Access Compliance Report

Public Rights-of-Way

(Curb Ramps)

Intersection ID: 10011755	Main Street: DAWN_CR	Cross Street: N/A	Location: S
ADA ID: 9473CF7A20B5	Ramp Type: Perp	Initial Pass/Fail: Fail	Overall Compliance: No
		Severity Score: 8.75	
Codes/Mitigation Info/Possible Solution		Field Measurements/Component Compliance

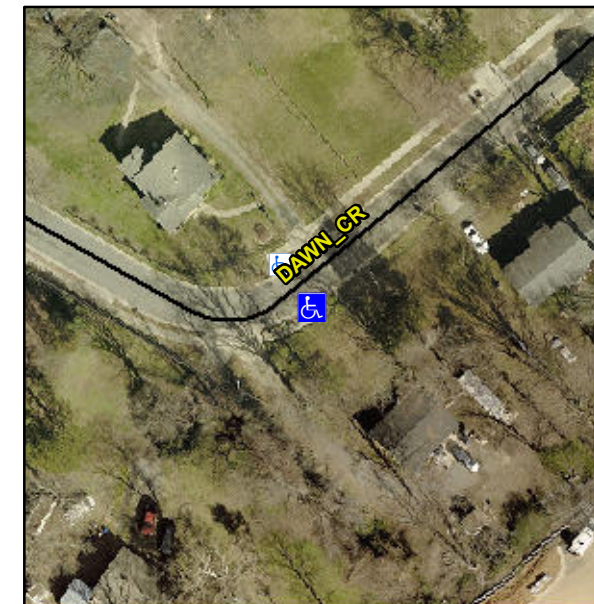
R304.5.1

Compliance	Description	Data	Compliance	Description	Data
N/A	Ramp Length (in)	86.0	Yes	Ramp Slope (%)	7.4
No	Ramp Width (in)	47.5	Yes	Ramp XSlope (%)	1.3
N/A	Flare Type LT	N/A	N/A	Flare Type RT	N/A
N/A	Flare Slope LT (%)	N/A	N/A	Flare Slope RT (%)	N/A
N/A	Flare Traversable LT?	N/A	N/A	Flare Traversable RT?	N/A
N/A	Landing Length (in)	N/A	N/A	DWS Provided?	N/A
N/A	Landing Width (in)	N/A	N/A	DWS Contrast?	N/A
N/A	Landing Slope (%)	N/A	N/A	DWS Length (in)	N/A
N/A	Landing X Slope (%)	N/A	N/A	DWS Full Width?	N/A
N/A	Landing Curb? (Y/N)	N/A	N/A	DWS Offset (in)	N/A
N/A	Shared Landing?	N/A			
N/A	Gutter Ponding?	N/A	N/A	Gutter Slope (%)	N/A
N/A	Gutter Lip Ht (in)	N/A	N/A	Gutter X Slope (%)	N/A
N/A	Painted X Walk1?	No	N/A	Painted X Walk2?	N/A
	X Walk 1 Direction	To N		X Walk 2 Direction	N/A
N/A	X Walk 1 Width (in)	N/A	N/A	X Walk 2 Width (in)	N/A
	X Walk 1 Slope (%)	0.8		X Walk 2 Slope (%)	N/A
	X Walk 1 X Slope (%)	2.3		X Walk 2 X Slope (%)	N/A

Remove & Replace Entire Ramp.
